Southern Nuclear Operating Company
Vogtle Electric Generating Plant Units 3 and 4
Request for License Amendment and Exemption:
Radiologically Controlled Area Ventilation System (VAS)
Design Changes (LAR-15-011)

Radiologically Controlled Area Ventilation System (VAS) Design Changes

(LAR-15-011)

UFSAR Figure 9.4.3-1 (Sheet 2 of 3) Radiologically Controlled Area Ventilation System Piping and Instrumentation Diagram (REF) VAS 003 & 010

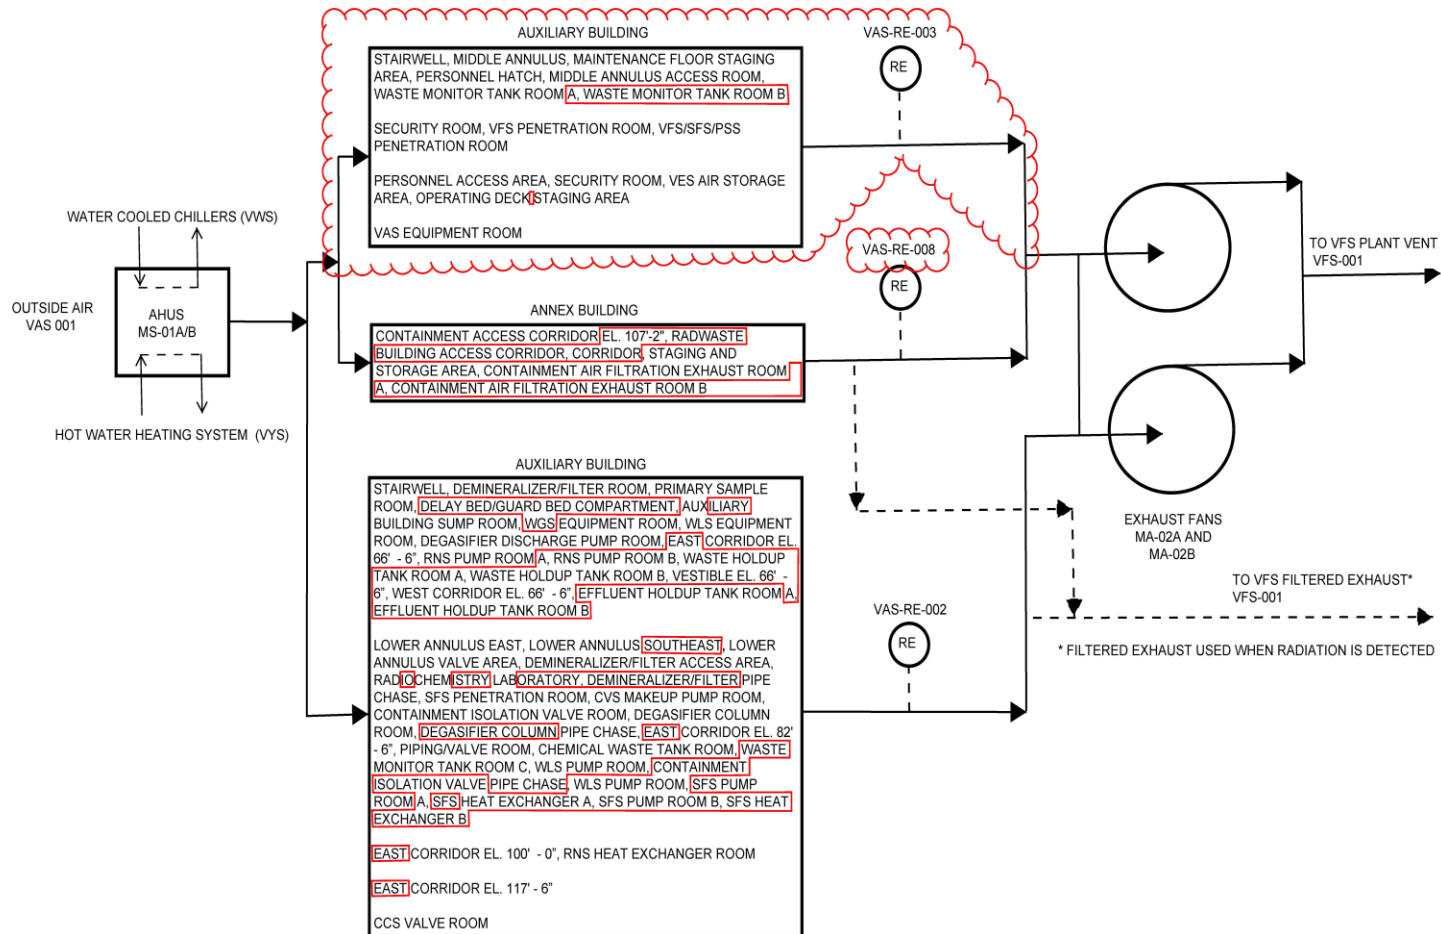
In the current UFSAR Figure 9.4.3-1 (Sheet 2 of 3), the radiologically controlled areas in the auxiliary building in both zones are shown as monitored by auxiliary building exhaust radiation detector VAS-JE-RE002, and the radiologically controlled areas in the annex building are shown as monitored by annex building exhaust radiation detector VAS-JE-RE003. This is incorrect, as annex building exhaust radiation detector VAS-JE-RE003 monitors both the annex building and portions of the auxiliary building in the first zone, while auxiliary building exhaust radiation detector VAS-JE-RE002 monitors the remainder of the auxiliary building in the second zone, as described in UFSAR Subsection 9.4.3.2.1.1. Therefore, the areas in the auxiliary building monitored by auxiliary building exhaust radiation detector VAS-JE-RE002 and renamed and relocated auxiliary building exhaust radiation detector VAS-JE-RE003 are separated and updated in UFSAR Figure 9.4.3-1 (Sheet 2 of 3) to be consistent with the exhaust radiation detector changes, to reflect current plant nomenclature, and to correct any editorial discrepancies in the names of the monitored rooms and corridors.

Table 2.1-1 below lists the radiologically controlled areas currently shown in UFSAR Figure 9.4.3-1 (Sheet 2 of 3) monitored by auxiliary building exhaust radiation detector VAS-JE-RE002, and the changes made to clearly define the areas monitored by either auxiliary building exhaust radiation detector VAS-JE-RE002 or renamed and relocated auxiliary building exhaust radiation detector VAS-JE-RE003. The names of the rooms and corridors are revised in UFSAR Figure 9.4.3-1 (Sheet 2 of 3) as necessary to reflect current plant nomenclature and to correct any editorial discrepancies, as shown in Table 2.1-1. Rooms and corridors to be monitored by new annex building detector VAS-JE-RE008 are shown in Table 2.2-1.

In the proposed change, UFSAR Figure 9.4.3-1 (Sheet 2 of 3) is updated to be consistent with the two zones as described in UFSAR Subsection 9.4.3.2.1.1, to be consistent with the exhaust radiation detector changes, and to revise the names of the rooms and corridors as necessary to reflect current plant nomenclature and to correct any editorial discrepancies. Auxiliary building exhaust radiation detector VAS-JE-RE002 continues to monitor the auxiliary building areas in the first zone as in the original design, and renamed and relocated auxiliary building exhaust radiation detector VAS-JE-RE003 monitors the remaining auxiliary building areas in the second zone. Additionally, annex building exhaust radiation detector VAS-JE-RE008 is added to provide radiation monitoring in the same zone containing the relocated auxiliary building exhaust radiation detector VAS-JE-RE003. Either auxiliary building exhaust radiation detector VAS-JE-RE003 or annex building exhaust radiation detector VAS-JE-RE008 can separately provide signals to alarm in the main control room, to initiate closure of the zone supply and exhaust air isolation dampers, to open the building exhaust air isolation damper for the associated zone to the containment air filtration exhaust units, and to start a containment air filtration exhaust unit. The individual exhaust ducting comprising each zone is not changed. The auxiliary building and annex building areas comprising each of the two zones are not changed. While the supply and exhaust ducting systems, and the auxiliary building and annex building areas comprising each of the two zones, are not changed, descriptions of auxiliary building and annex building areas that are part of each zone as shown in UFSAR Figure 9.4.3-1 (Sheet 2 of 3) require revision to be consistent with the UFSAR Subsection 9.4.3.2.1.1 text description.

Revise Figure as shown below:

<u>Plant Specific Licensing Basis Document Changes</u>	<u>Description of Proposed Change(s)</u>
UFSAR Figure 9.4.3-1 (Sheet 2 of 3)	Revise names of the rooms and corridors as necessary to reflect current plant nomenclature and to correct any editorial discrepancies, as shown in Table 2.1-1.
UFSAR Subsection 11.5.2.3.2	<p>Under the subtitle ‘Auxiliary Building Exhaust Radiation Monitor,’:</p> <ul style="list-style-type: none"> • 1st paragraph is revised to ‘... radiation monitors (VAS-JE-RE002 and VAS-JE-RE003) measure the concentration ...’ • 2nd paragraph is revised to ‘...initiate closure of the affected radiologically controlled area ventilation system zone supply and exhaust air isolation dampers, to open the radiologically controlled area ventilation system zone exhaust air isolation damper to the containment air ventilation exhaust units...These actions provide a filtered air path from the affected radiologically controlled area ventilation system zone to the plant vent.’ • 3rd paragraph is revised to ‘... radiation monitors are inline monitors that use a beta-sensitive scintillation detector. The detectors are located ...’ • 4th paragraph is revised to ‘... exhaust radiation monitors are shown in Figure 11.5-5.’

UFSAR Figure 9.4.3-1 (Sheet 2 of 3)	Revise names of the rooms and corridors as necessary to reflect current plant nomenclature and to correct any editorial discrepancies, as shown in Table 2.2-1.
UFSAR Subsection 11.5.2.3.2	Under Subtitle 'Annex Building Exhaust Radiation Monitor,' : <ul style="list-style-type: none"> • 1st paragraph to read '... exhaust radiation monitor (VAS-JE-RE008) measures the' • 2nd paragraph is revised to '...initiate closure of the affected radiologically controlled area ventilation system zone supply and exhaust air isolation dampers, to open the radiologically controlled area ventilation system zone exhaust air isolation damper to the containment air ventilation exhaust units...These actions provide a filtered air path from the affected radiologically controlled area ventilation system zone to the plant vent.'
UFSAR Table 11.5-1	Add line item for detector 'VAS-JE-RE008,' with type as 'β,' with service as 'Annex Building Exhaust (Note 5),' with isotopes as 'Kr-85 Xe-133,' and with nominal range as '1.0E-7 to 1.0E-2 μCi/cc.'
